Product Change Notification / GBNG-09EEJB041

CCB 3473.001 Final Notice: Qualification of ASE as a new assembly site for selected Micrel KSZ8061 device family available in 32L VQFN (5x5x0.9mm) package using palladium coated copper with gold flash (CuPdAu) bond wire.

CCB 3473.001
Pre and Post Change Summary
PCN #: GBNG-09EEJB041

TICP

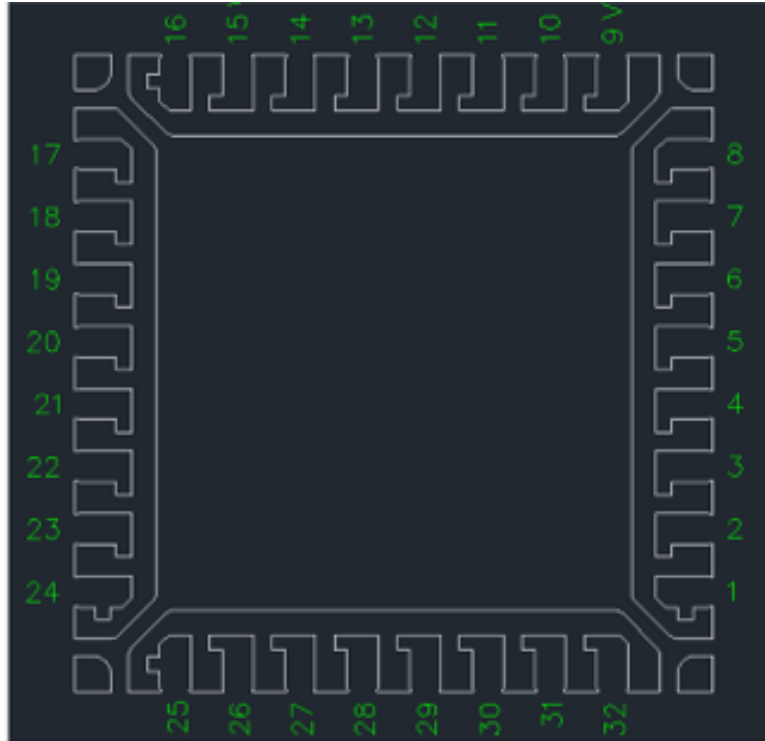
Lead frame paddle size

150x150 mils

ASE

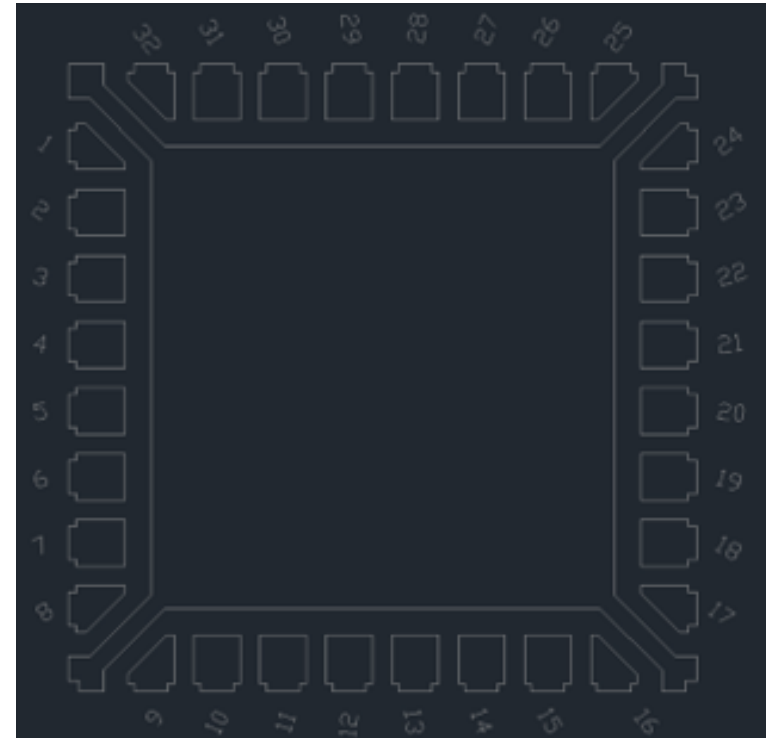
Lead frame paddle size

138x138 mils
